From: **Quimby, Frank** <frank_quimby@ios.doi.gov>
Date: Mon, Jan 30, 2017 at 1:56 PM
Subject: heads-up on a BOEM news release slated to go later this week or next
To: Megan Bloomgren <(b)(6)>, Heather Swift
(b)(6)>, Douglas Domenech <douglas.w.domenech@ptt.gov>

3. Assumptions in the Draft SEIS are Unrealistically Conservative and Do Not Reflect Actual GOM Conditions

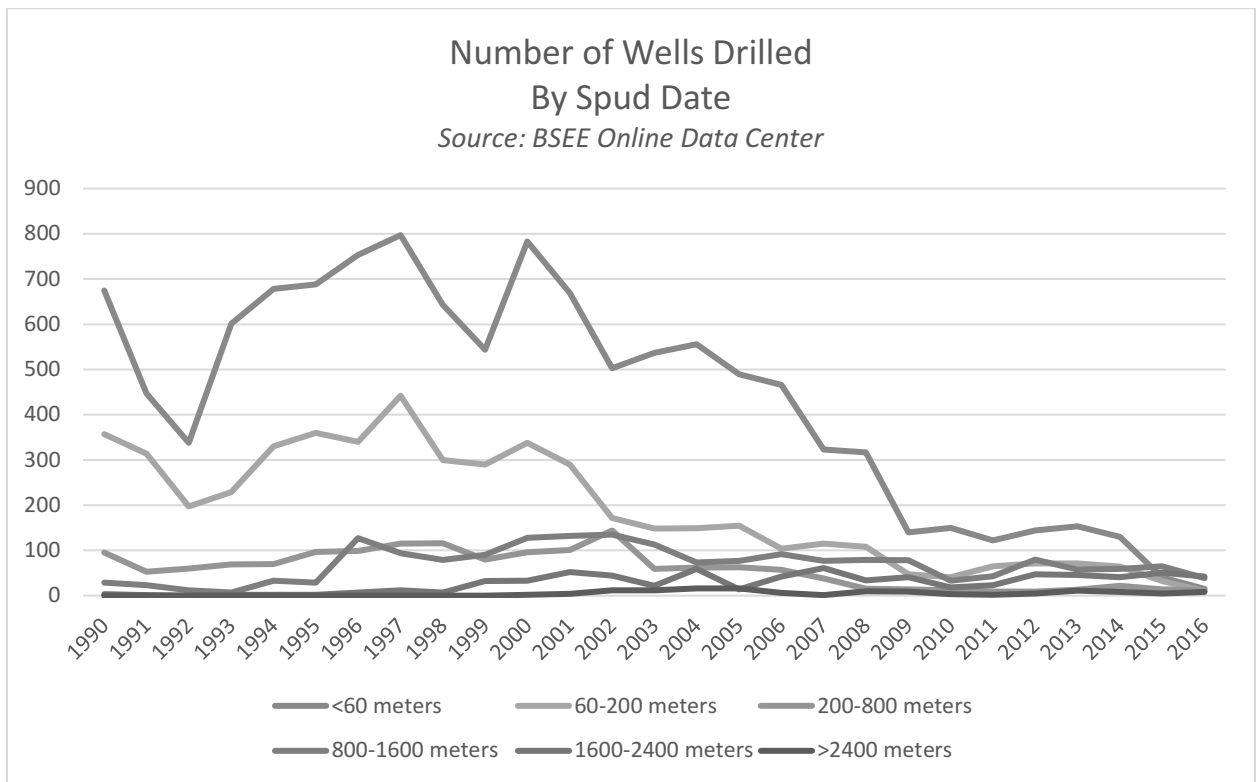
- Figure C-15 in the Draft SEIS appears to overpredict the future number of platforms in shallower water depths, particularly platforms in less than 60 m of water. A review of Figure C-15 reveals that BOEM's future predictions show 137 new platforms (60% of the future total) in less than 60 m water depth. However, Figure C-15 does not account for historical trends nor ongoing platform removals. Using data from BSEE's Online Data Center, the Joint Trades have determined that for each year from 1990 to 2016, platform removals exceed platform installations in water depths less than 60 m (see chart below). Therefore, GOM activity in areas of less than 60 m water are centered on structure removal not installation. Any future projections must account for this type of historical trend.

Similarly, the number of wells drilled annually since 1990 has dramatically declined in shallower water depths (less than 200 meters). As the chart below demonstrates, activity as measured by the number of wells drilled is shifting from shallower water depths to deeper waters. Any future projections on platform locations used in the GOM Air Quality Modeling study and Draft SEIS should account for these trends to realistically represent future GOM projections.

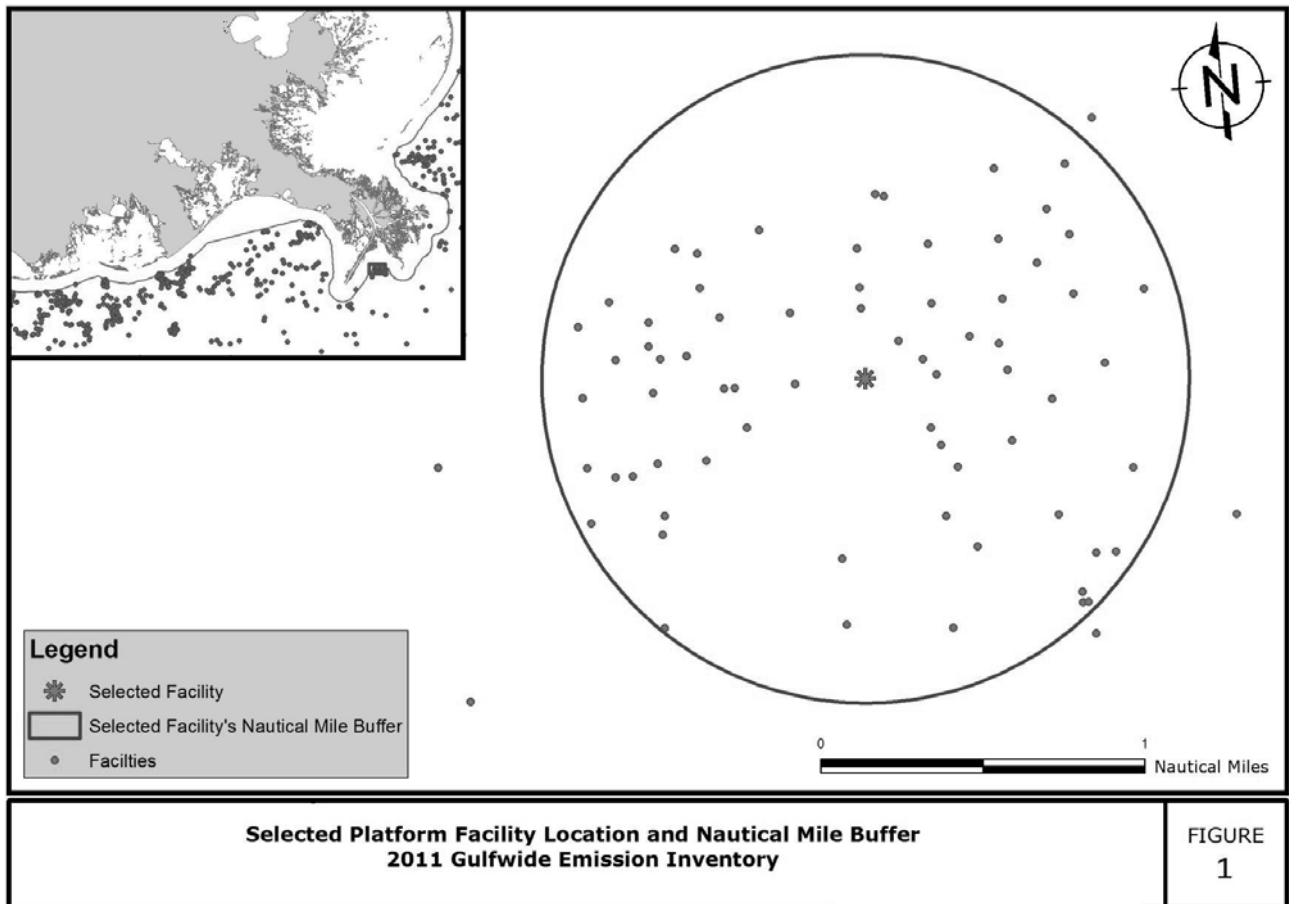
Inventory.²⁸ In Figure 1, the single facility at the center of the circle with a one mile radius could potentially be consolidated with 69 other facilities. Figure 2 demonstrates the potential daisy chain effect by including circles of one mile radius for each of these 69 facilities. Together, these figures demonstrate that, aside from the fact that consolidation of facilities is unnecessary, consolidating facilities within a one mile radius of each other could be impractical and unworkable from a data-gathering and plan approval perspective.

Under the proposed rule, a proposed facility would potentially be required to identify emissions from multiple facilities (and their associated MSC) and to address the aggregated emissions in an EP, DPP, or DOCD. However, implications of consolidations for the existing facilities is not clear. Per proposed § 550.303(d)(4), if a designated operator is required to consolidate multiple facilities, then anywhere a requirement applies to “projected emissions” it would instead apply to “complex total emissions.”

If emissions from the proposed facility do not cause onshore concentrations that exceed a SIL but emissions from the consolidated facility do, it is not clear whether the new facility, the existing facility, or both would implement ERMs. The proposed text in § 550.306(5) refers to selecting reasonable operational controls to “limit your facility’s projected emissions to the greatest practicable extent.” Section 550.307(a), states that “you must apply ERM for the facility.” This would suggest that ERM is only required for the facility described in the plan.

Figure 1 - BOEM Estimates of Benefits and Costs for the Proposed Rule

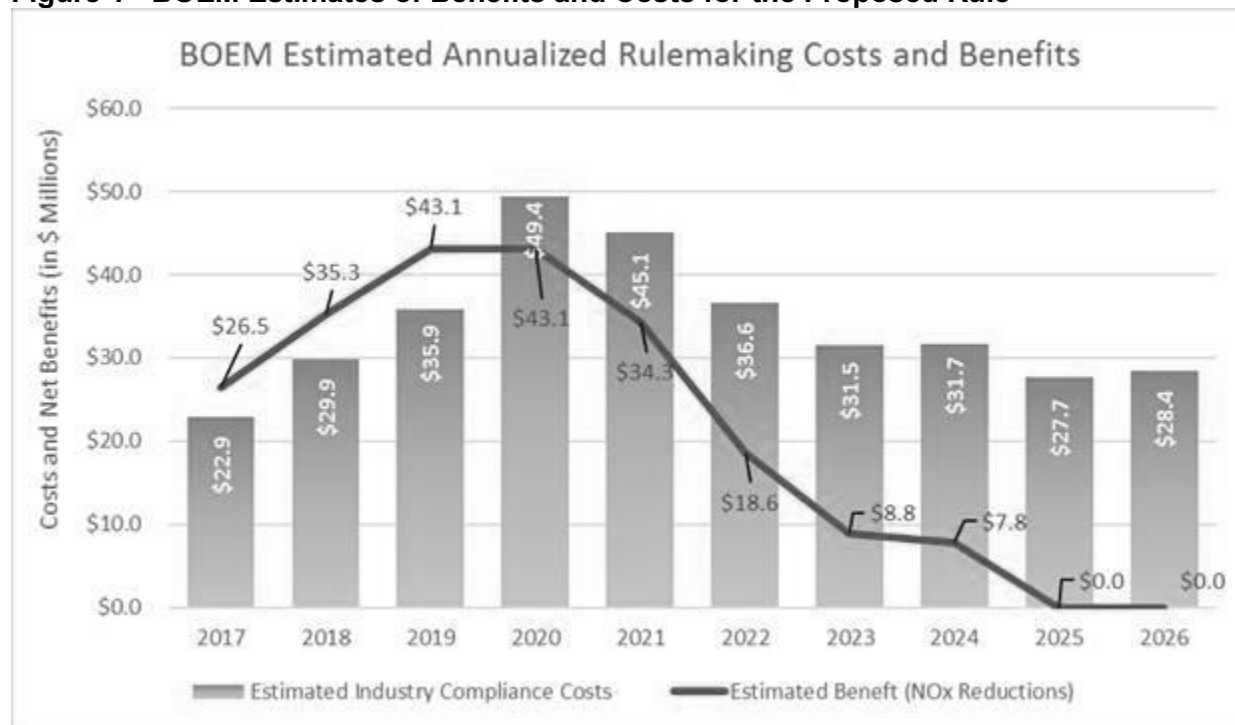
In fact, the agency's analysis shows that over the course of the 10 year window of analysis, the total net cost of the proposed rule approaches \$122 million dollars, compared with a benefit that declines to zero after eight years (see Figure 1).

Based on the cost and benefit data presented in Figure 1, promulgation of the proposed rule would violate OCSLA's mandate of a reasoned balancing of "expeditious and orderly development" and environmental safeguards. It also would contravene the updated Executive Order (E.O.) 13563, which reaffirms E.O. 12866 and further states that agencies must,

Figure 2 –Comparing Estimates of Compliance Costs

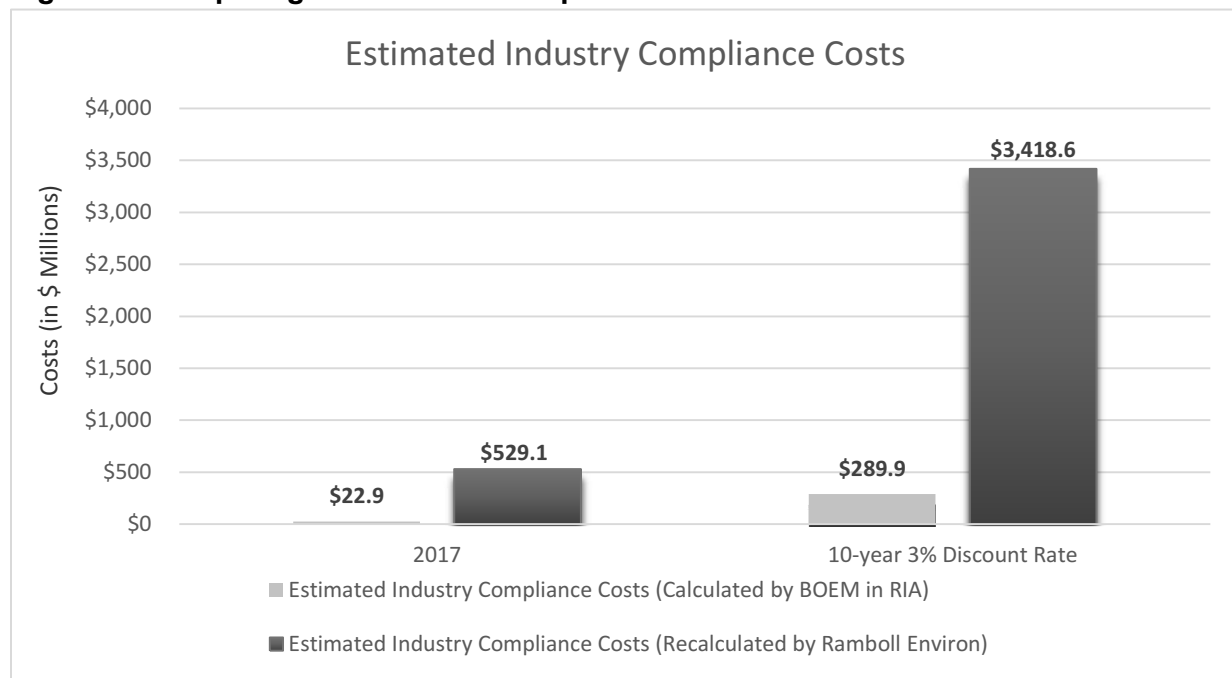
Table 1 shows a comparison of BOEM's calculation of compliance costs compared to the compliance costs as recalculated within this analysis. The first year costs are estimated to be approximately \$23 million by BOEM, and over \$529 million by Ramboll Environ, representing a 23 fold increase. The ten year costs similarly represent a 12 fold increase over the BOEM estimates. The same data are shown graphically in Figure 2.

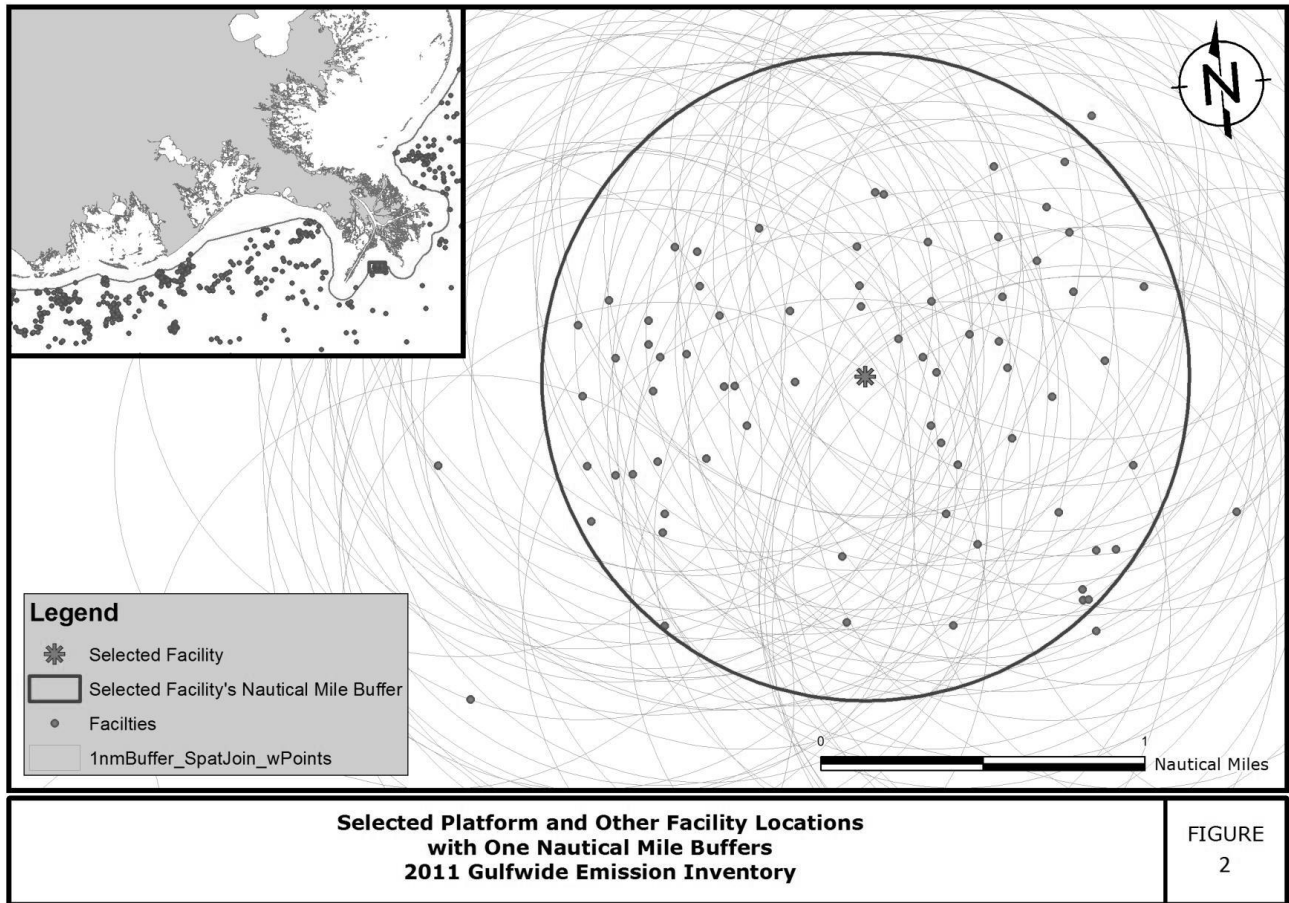
Inventory.²⁸ In Figure 1, the single facility at the center of the circle with a one mile radius could potentially be consolidated with 69 other facilities. Figure 2 demonstrates the potential daisy chain effect by including circles of one mile radius for each of these 69 facilities. Together, these figures demonstrate that, aside from the fact that consolidation of facilities is unnecessary, consolidating facilities within a one mile radius of each other could be impractical and unworkable from a data-gathering and plan approval perspective.

Under the proposed rule, a proposed facility would potentially be required to identify emissions from multiple facilities (and their associated MSC) and to address the aggregated emissions in an EP, DPP, or DOCD. However, implications of consolidations for the existing facilities is not clear. Per proposed § 550.303(d)(4), if a designated operator is required to consolidate multiple facilities, then anywhere a requirement applies to “projected emissions” it would instead apply to “complex total emissions.”

If emissions from the proposed facility do not cause onshore concentrations that exceed a SIL but emissions from the consolidated facility do, it is not clear whether the new facility, the existing facility, or both would implement ERMs. The proposed text in § 550.306(5) refers to selecting reasonable operational controls to “limit your facility’s projected emissions to the greatest practicable extent.” Section 550.307(a), states that “you must apply ERM for the facility.” This would suggest that ERM is only required for the facility described in the plan.

Figure 1 - BOEM Estimates of Benefits and Costs for the Proposed Rule

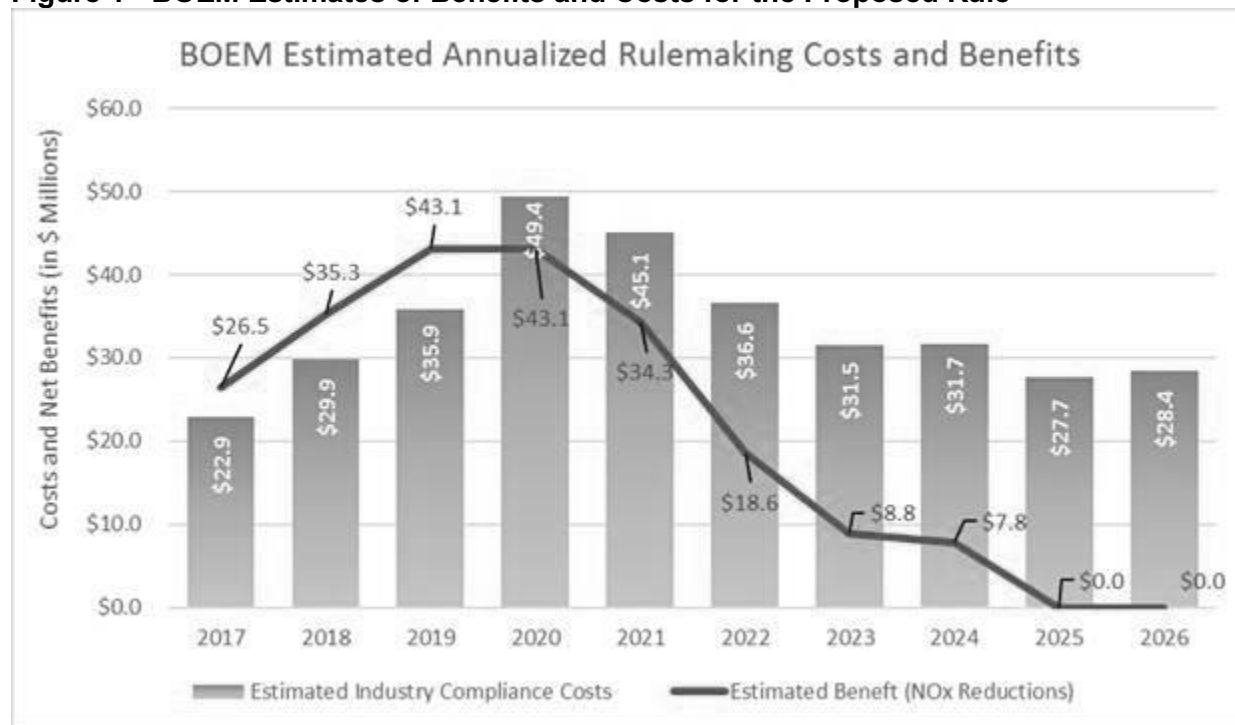
In fact, the agency's analysis shows that over the course of the 10 year window of analysis, the total net cost of the proposed rule approaches \$122 million dollars, compared with a benefit that declines to zero after eight years (see Figure 1).

Based on the cost and benefit data presented in Figure 1, promulgation of the proposed rule would violate OCSLA's mandate of a reasoned balancing of "expeditious and orderly development" and environmental safeguards. It also would contravene the updated Executive Order (E.O.) 13563, which reaffirms E.O. 12866 and further states that agencies must,

Figure 2 –Comparing Estimates of Compliance Costs

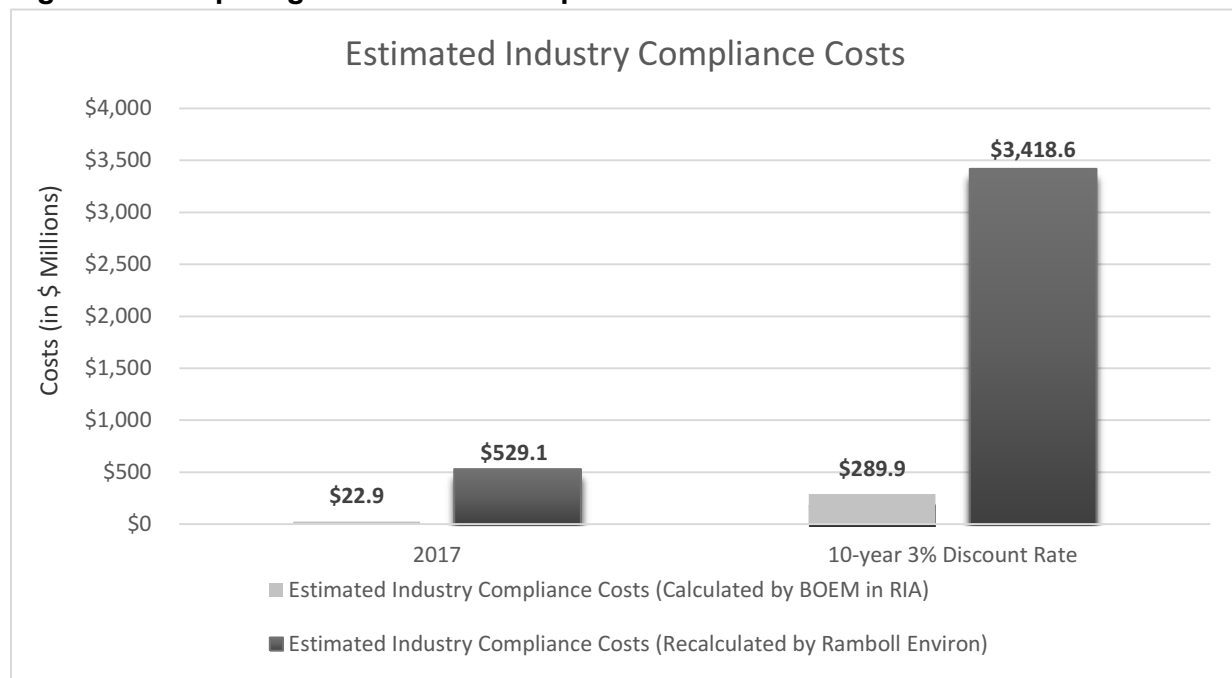
Table 1 shows a comparison of BOEM's calculation of compliance costs compared to the compliance costs as recalculated within this analysis. The first year costs are estimated to be approximately \$23 million by BOEM, and over \$529 million by Ramboll Environ, representing a 23 fold increase. The ten year costs similarly represent a 12 fold increase over the BOEM estimates. The same data are shown graphically in Figure 2.

Figure 3 –Available Air Quality Credits in Louisiana

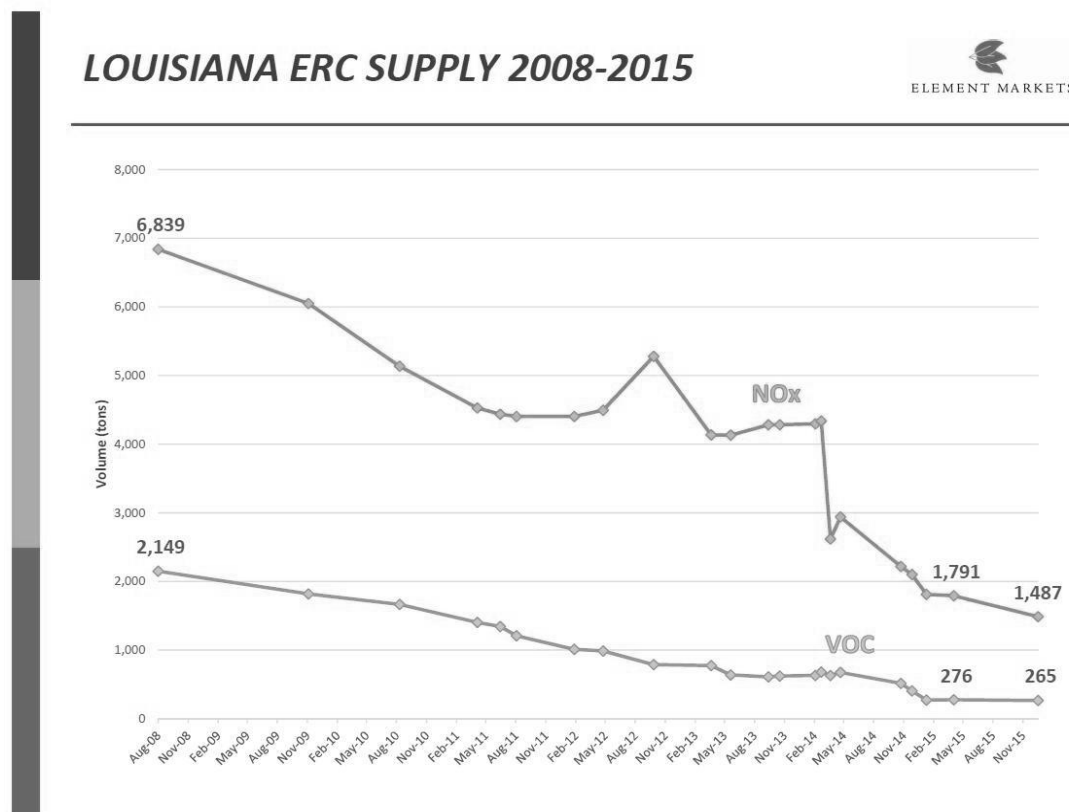
For ozone non-attainment areas in Louisiana, the price of NO_x allocation credits has fluctuated between \$3,000-5,000 per ton for fifteen years, until recent expansions in the non-attainment area. Since the expansions, the availability of credits has dropped by nearly 80 percent, and **NO_x allocation credits have now ranged in price from \$18,000-25,000 per ton** for credits expiring in ten years⁶. Figure 3 shows the dramatic decline in availability of NO_x emission reduction credits (ERC) in Louisiana over the last seven years. The decreased supply correlated to increased difficulty and expense in obtaining credits. If more firms decide to participate in a NO_x trading market due to this rule, general economic theory suggests that demand for credits will increase, the availability of credits decrease, and the price increase. There could be a disproportionately negative impact on smaller firms.

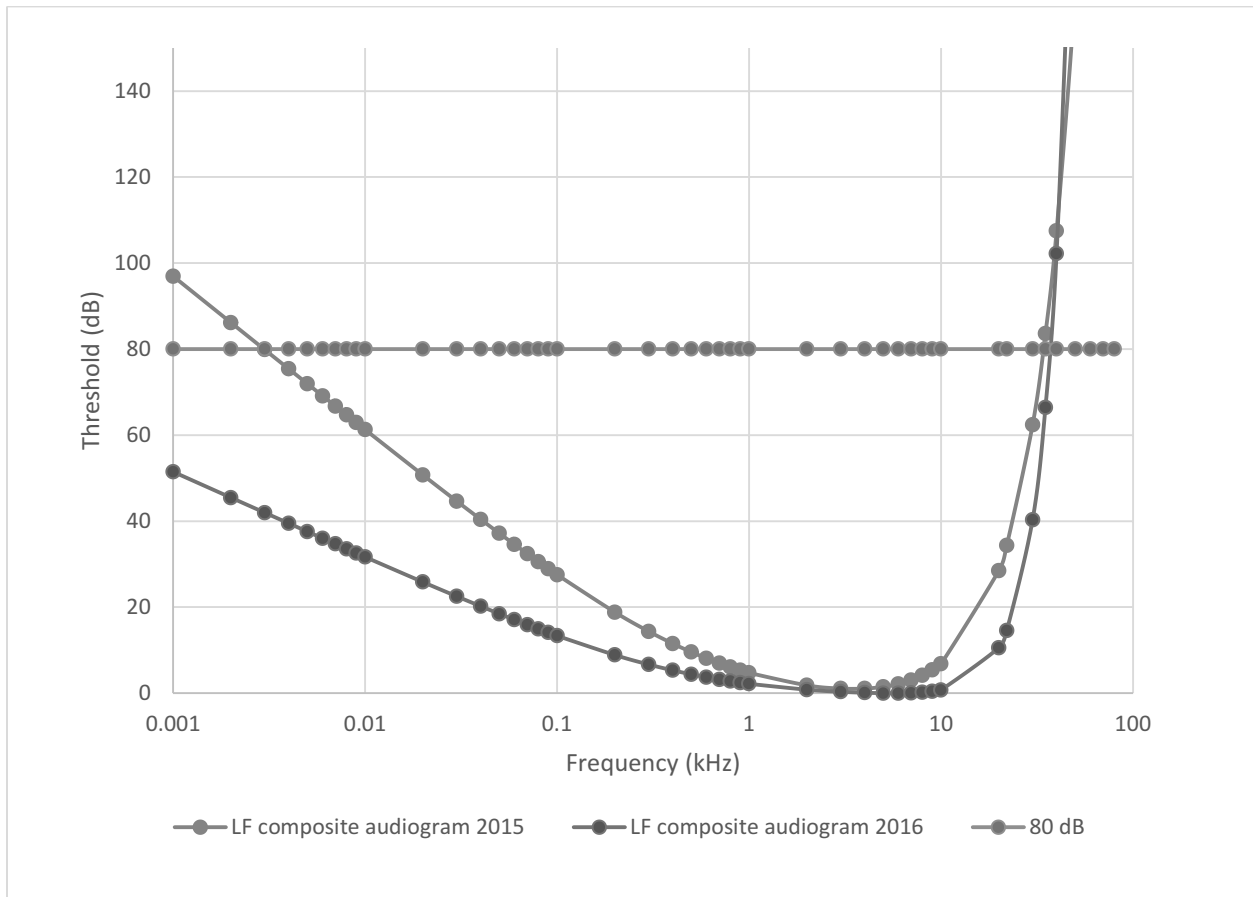
Figure 1. The consequence of the proposed changes to the LF cetacean modeled audiogram (in red) produce a hearing curve at the lowest frequencies that never approaches the 80 dB decrement from best hearing (in green) that NOAA had set as the upper and lower limiting frequencies of hearing (also a general mammalian metric of upper and lower hearing limits). The July 2015 modeled hearing curve (in blue), on the other hand, produces a crossing point with the 80 dB threshold at 3 Hz that provides a reasonable if generous lower limit of hearing.
